DATE: February 5, 2015
TO: Steve Lewis, City Manager
FROM: Shawn O'Leary, Director of Public Works
City Flood Plain Administrator
SUBJECT: University House Addition (aka Bishop's Landing)
Flood Plain Concerns

I am writing in reply to a number of concerns in recent days and weeks regarding the captioned subject. The City Flood Plain Permit Committee approved Flood Plain Permit No. 553 on December 1, 2014 for the proposed University House Addition on the condition that the City Council must also authorize specific elements of the permit as part of the consideration of the preliminary plat application. The preliminary plat application is currently scheduled for consideration by the City Council on Tuesday, February 10, 2015.

Attachment 2

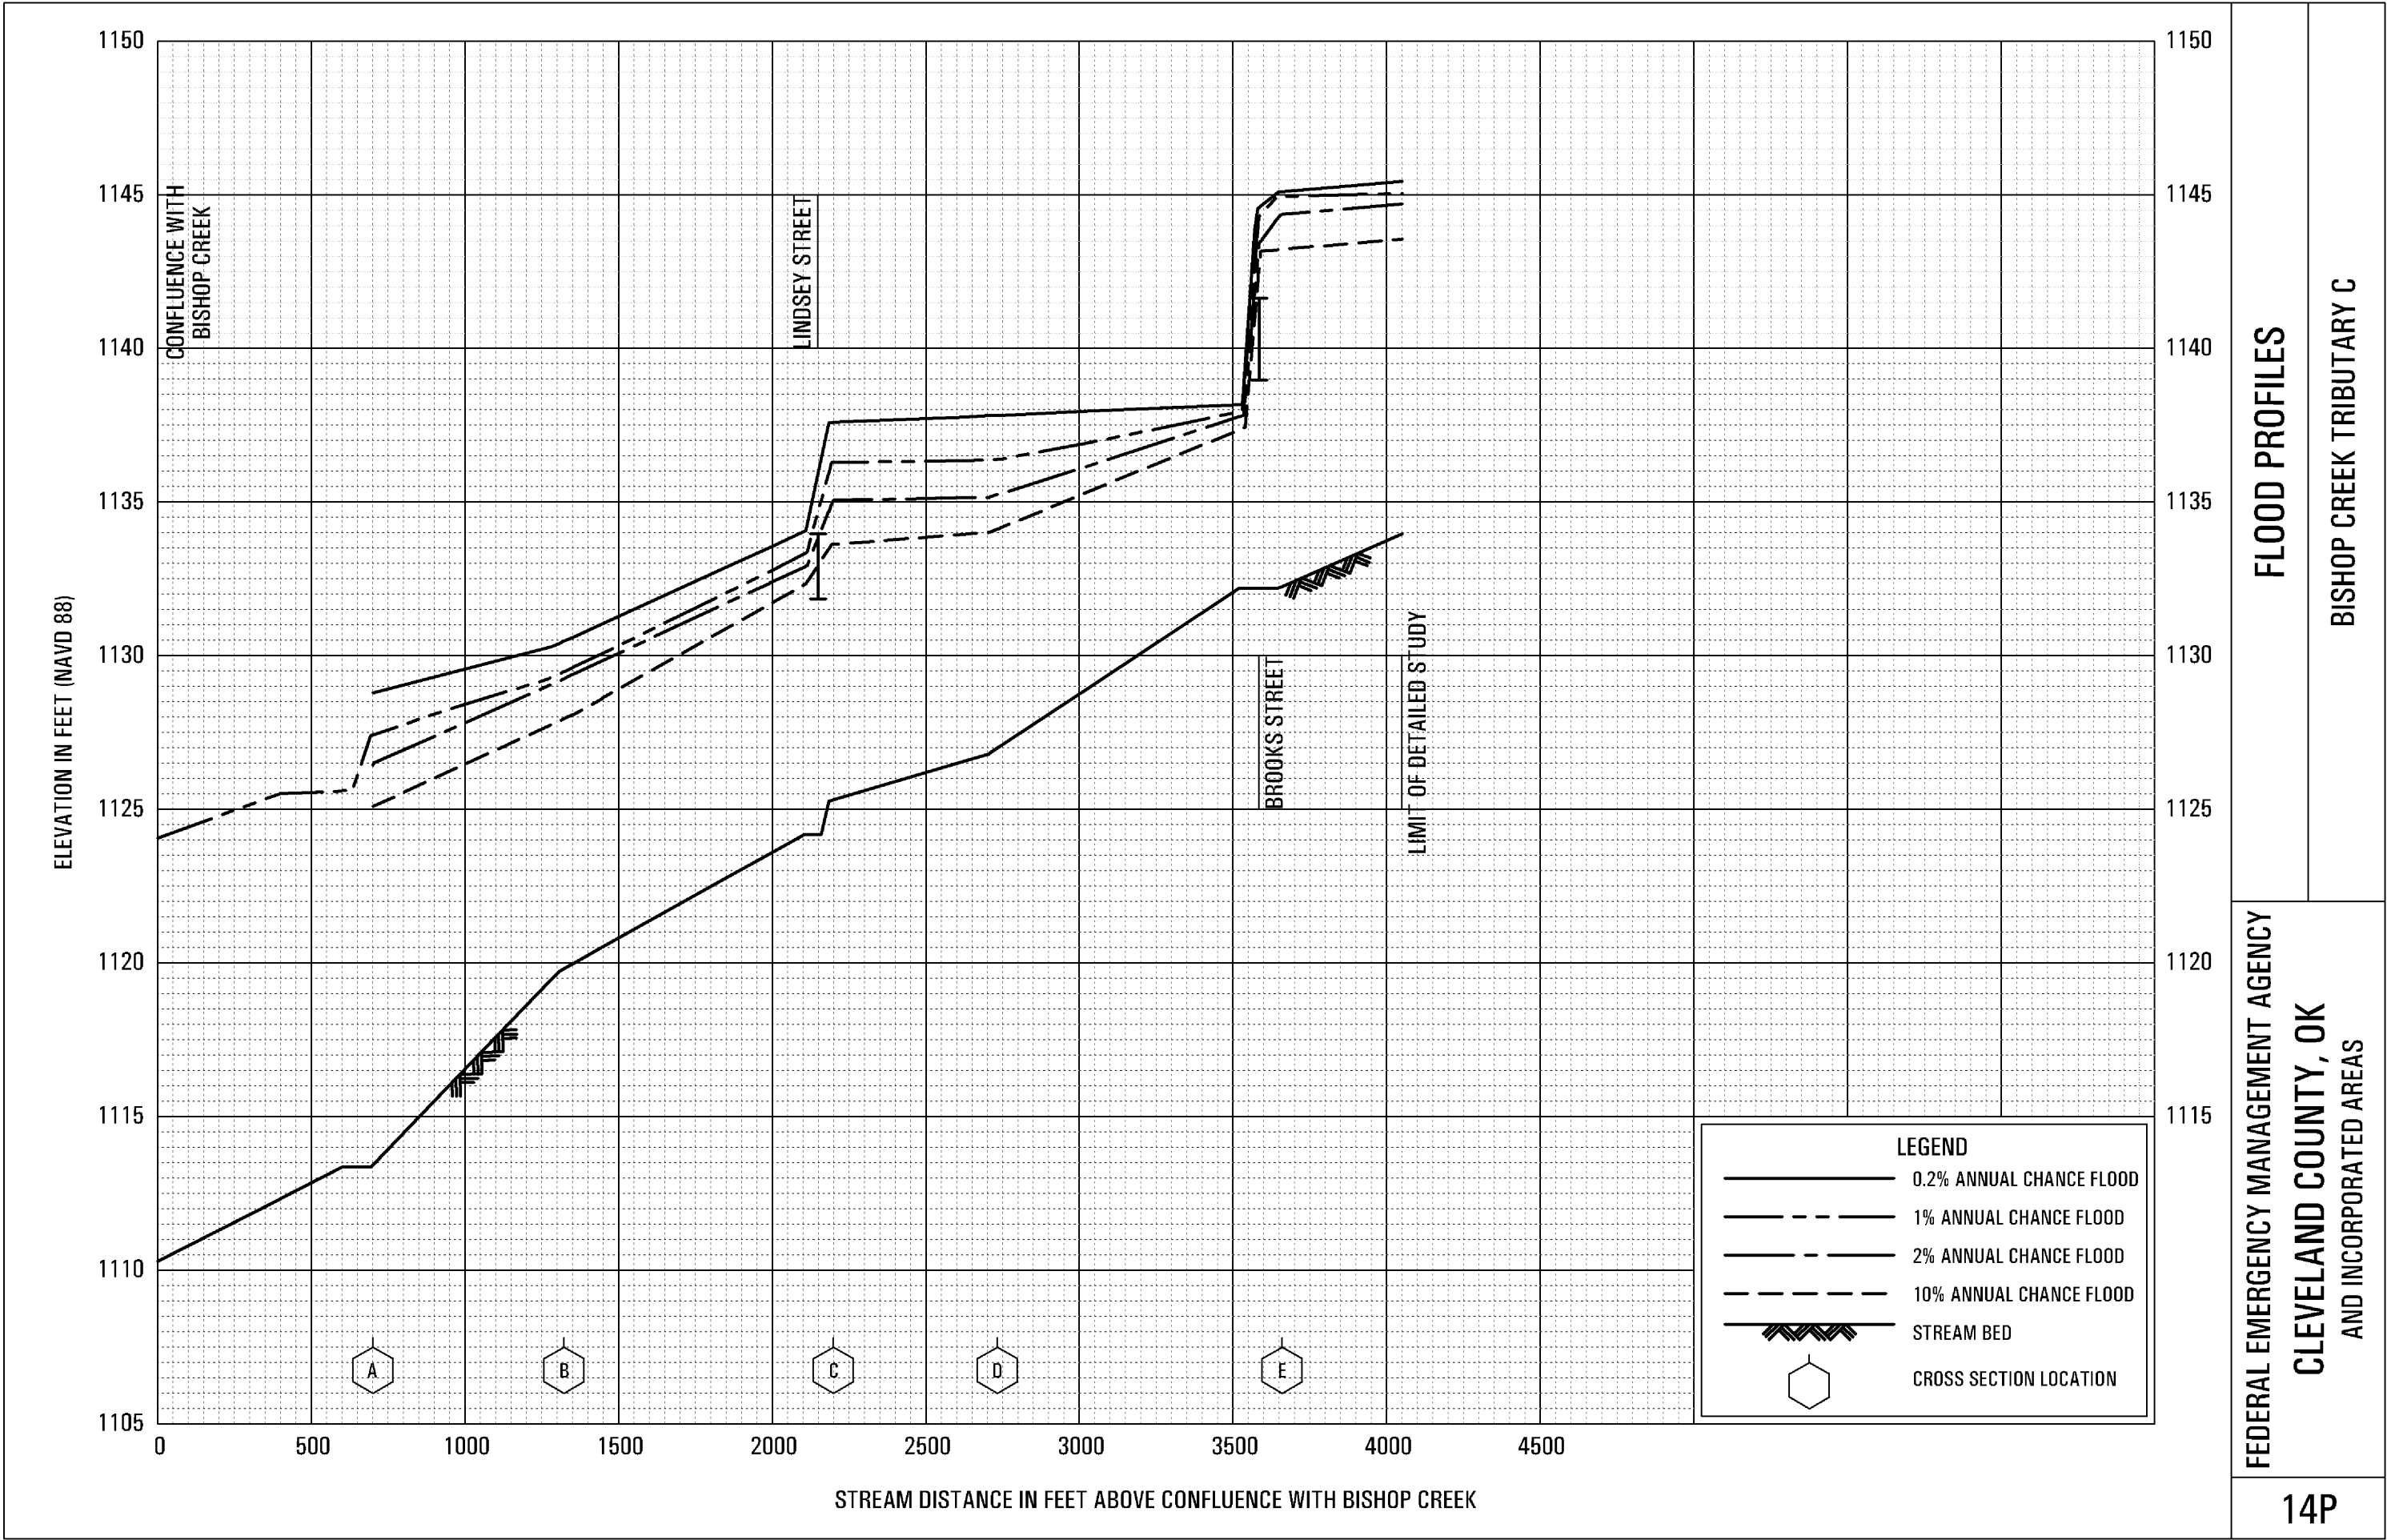
The Developer's engineer, Mr. Dean Koleada, P.E., of Huitt-Zollers, Inc., submitted existing and proposed floodplain mapping as part of the floodplain permit application. Although Mr. Koleada's "Proposed Conditions Map" indicates a rise in the BFE just south of the reinforced concrete box (RCB) bridge on Brooks Street, Mr. Koleada has determined that the existing Federal Emergency Management Agency (FEMA) flood plain map in this portion of Bishop Creek is inaccurate. Thus, Mr. Koleada's "Proposed Conditions Map" is not indicating a rise in the BFE, but is actually a more accurate representation of the flood plain map downstream of Brooks Street (Attachment 2).

The FEMA Effective floodplain boundary lines shown crossing Brooks street are not consistent with the actual topography along Brooks. The BFE shown on the FIRM Map at cross section E-E is 1144, but the floodplain lines cross Brooks Street at an elevation of 1141.8. This implies that there could be an error in the FEMA model at the culvert under Brooks. This error could incorrectly allow more water to flow through the culvert than its actual capacity would allow. This error would lower the downstream BFE's incorrectly. In addition to the floodplain boundary line error, we found a discrepancy in the FEMA BFE at cross section E-E. An elevation of 1144 is shown on the FEMA FIRM Map, but the FEMA Flood Insurance Study (FIS) Flood Profile 14P shows the elevation to be 1145.

These discrepancies confirm that the effective FEMA models and information have errors that need to be corrected. Therefore the FEMA data at this location should not be relied upon, and the "existing conditions" model prepared by Huitt-Zollars, Inc. should serve as the corrected model for this area.
